# Part 8 Chief Executive's Report

# N62 Slievenamon Road Phase 2 Road Improvement Scheme

October 2022

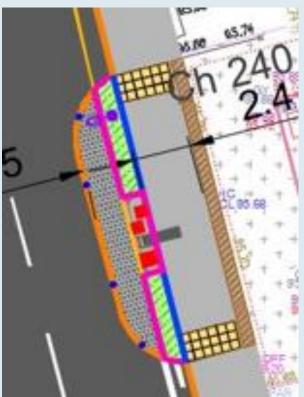
The chambers housing the underground offset fill points and the vapour recovery line are both currently located at the outer edge of the existing footpath. The planned improvement works and the proposed reduction of the carriageway width to 5.5m overall, (2 x 3.25m lanes) and provision of the planter at this location, will result in the outer edge of the oil tanker being at or virtually at the centreline of the roadway while making a fuel delivery.

The proposed positioning of planter beds in the vicinity of entry/exit crossovers, the crossover widths provided for tanker entry/exit and the proposed radii of kerbing/walling of the planters at the entry/exit points all cause problems/concerns for the oil tanker entering the site and several adjustments would be required to these elements to provide safe access and egress to the forecourt for the oil tanker.

Soft landscaping placed directly outside the petrol station means the oil truck will have to park on the road to deliver fuel which will cause undue disruption and traffic delays. Soft landscaping outside the butcher shop unnecessarily removes parking space, which could be made available to the residents of the road. The submission raises concerns with the trip hazard associated with planting and soft landscaping.

The proposed layout has been amended to maintain the existing loading arrangements i.e. parking in front of the entrance/forecourt on Slievenamon Road. The proposed planting area in front of the canopy has been removed and replaced with imprinted concrete to the existing kerbline to facilitate current unloading operations, see below.

As shown above, itt is proposed to maintain the existing delivery arrangements by replacing the previously proposed soft landscaping with a hard-surface set down area which maintains the position of the existing kerbline/edge of footpath. The hard surface material will be confirmed at detailed design stage, but will be a durable surface appropriate to the expected vehicle loading. The fuel delivery points will be incorporated into the layout in their current location with a concrete apron constructed to provide separation from the new hard surface set down area and the proposed adjacent grass verge. A series of bollards are proposed to provide a means for the proprietor to control unauthorised overnight parking thereby ensuring that the area is available to delivery vehicles when required. It is anticipated that existing N62 traffic movements will be unaffected by maintaining the current delivery arrangements i.e. existing southbound traffic travelling from Liberty Square
